TECHNICAL SERVICE BULLETIN

Technical Service Bulletin: 10-08052016-0236

Forest River – Office of Corporate Compliance (“OCC”) has decided that a Technical Service Bulletin (“TSB”), is required to address the vehicle in your ownership.

Figure A. – Location of Control Module Box serial number.

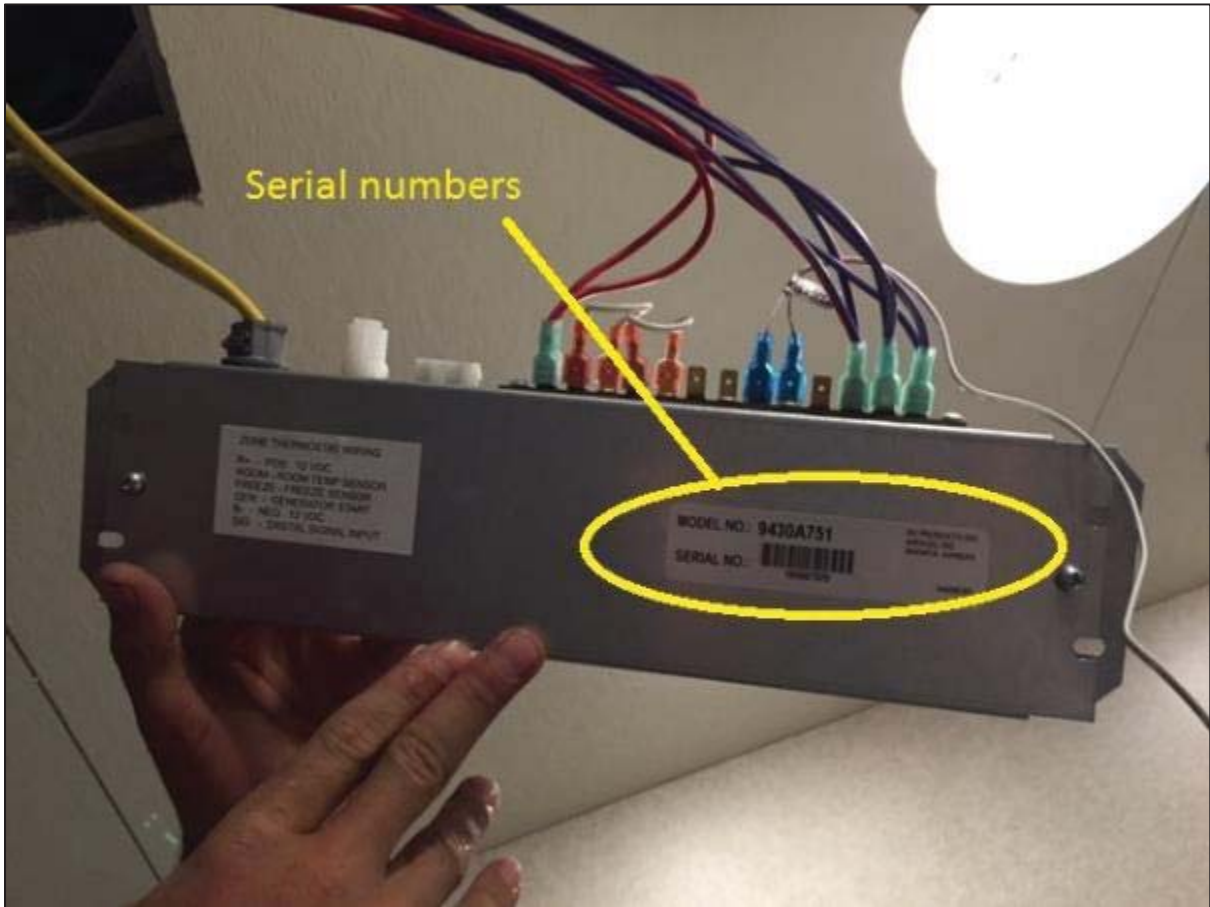
The bedroom A/C Control Module boxes should have a sticker on the face plate of the box that has a part number of 9430A755.

- If the part number “9430A751” is labeled on the Control Module Box; the Heat Strip will not operate.
- The Control Module Box will need to be replaced with part number “9430A755”; which connects to the wiring exactly the same as the Control Module Box being replaced.

Lower the Control Module Box down from Air Conditioner compartment, inspect the serial number ([Figure A](#));

Figure C. – 12V Sensor and Power Wire Schematic

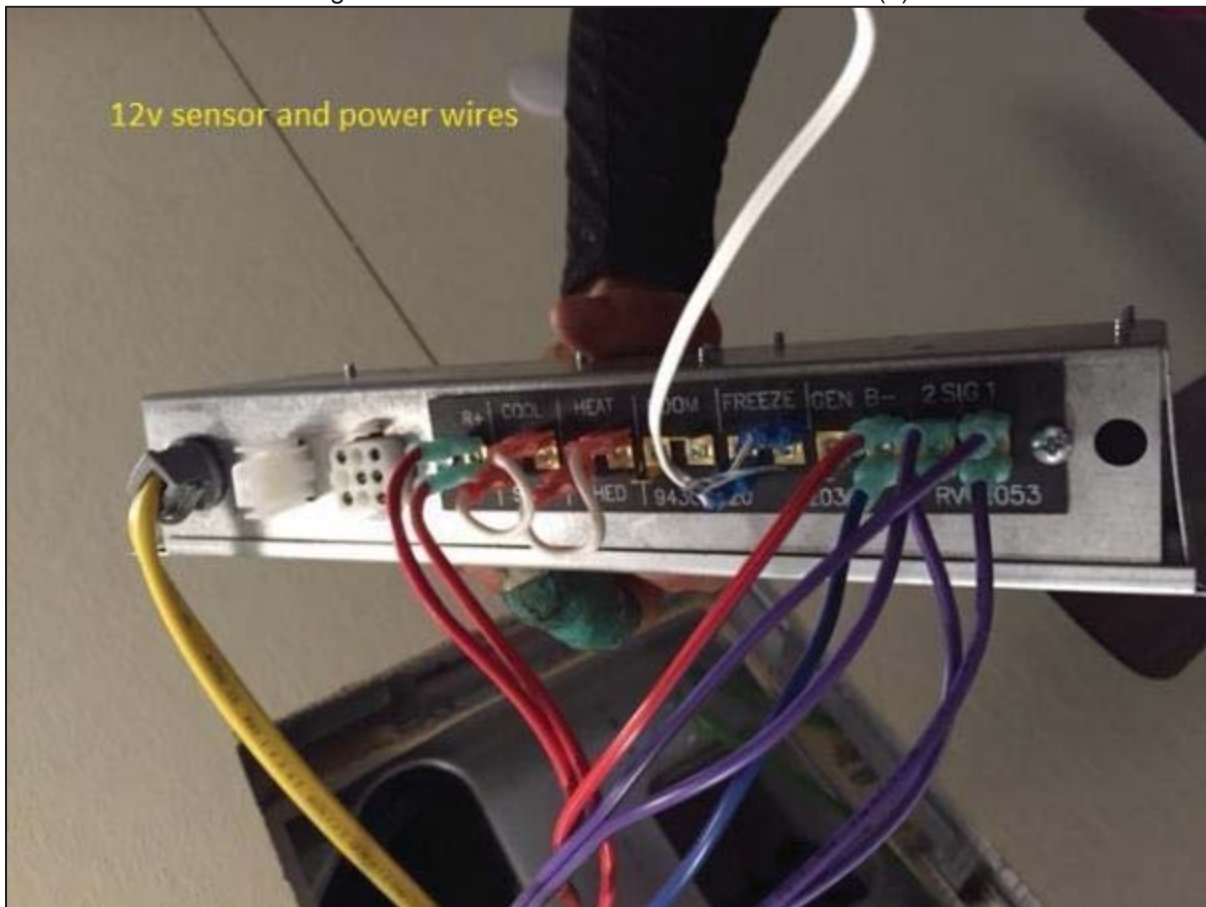
6. Unscrew 2 square head screws that secure that face plate of the Control Module Box;
7. Unplug the 2 wire harnesses
 - a. Note one from the Air Conditioner
 - b. Note one from the Heat Strip Box
8. Locate 3 Yellow Wire Nuts (these may be taped with electrical tape) that the 12/2 Romex 110V Wire is connected to and remove the wire from the Control Module Box ([Figure B](#));
9. Simply, but gently disconnect each of the 12V Power and Sensor wires that are connected to the Control Module Box; ([Figure C](#))
10. Reverse all steps to install the 9430A755 control module box. ([Figure D](#))
